**IMPERIAL ROAD DESIGN MANUAL
REVISIONS January, 2015**

- Page A-95 – Added the following language; “*Drainage Grates*”

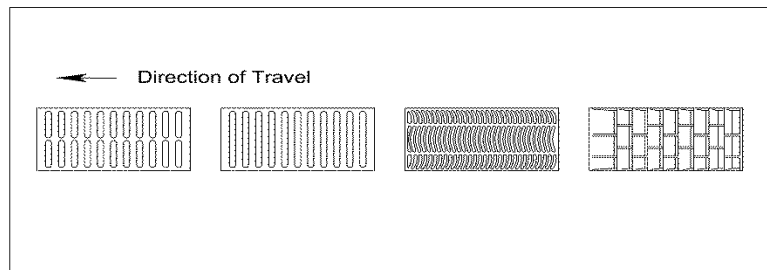
Grates shall be placed perpendicular to the direction of travel and the gaps between the drainage grate and its frame shall not be greater than 1 inch. Grates shall be within 0.25 inch of the new road surface. “
